PCM Service Update

#SUP2003-03

Oil Pressure Switch

Engines Affected: MEFI 4 Equipped Engines With an Oil Switch Failure or Intermittent Power Reduction Mode

1. Vent Hole (smaller)
2. Sealed Hole (larger)
3. Terminal

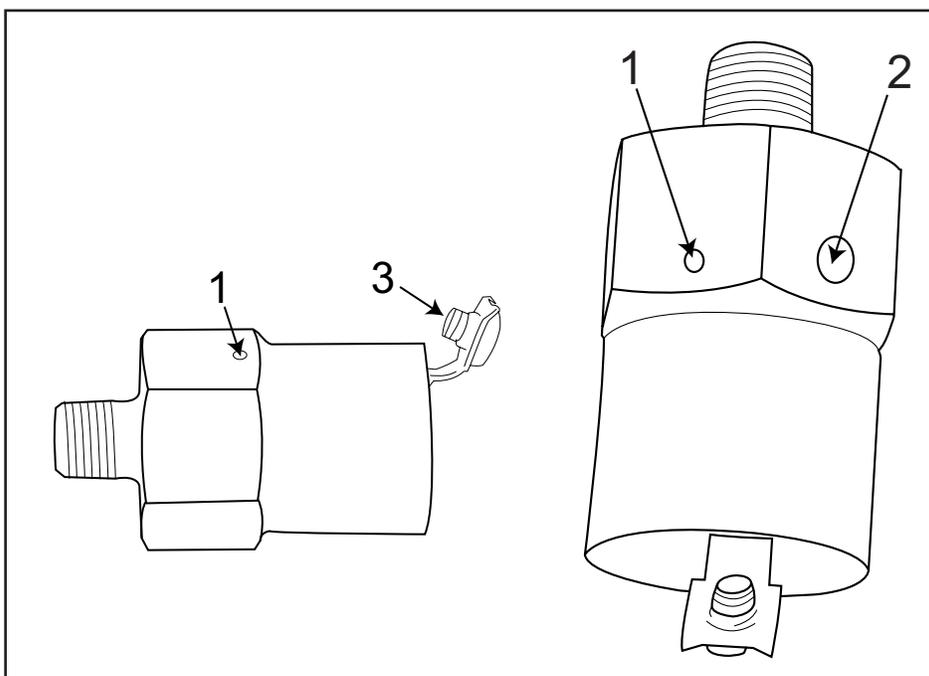
Recently there have been some isolated cases of engines going into power reduction. The problem appears to be water or moisture entering the switch through the vent hole of the oil pressure switch (see drawing). If you encounter a customer complaining of this type symptom, try to verify the concern. If the problem is diagnosed as a defective switch, install a new oil pressure switch, part number R020015A, with the vent hole indexed facing down. This will help reduce the chance of water or moisture entering the switch.
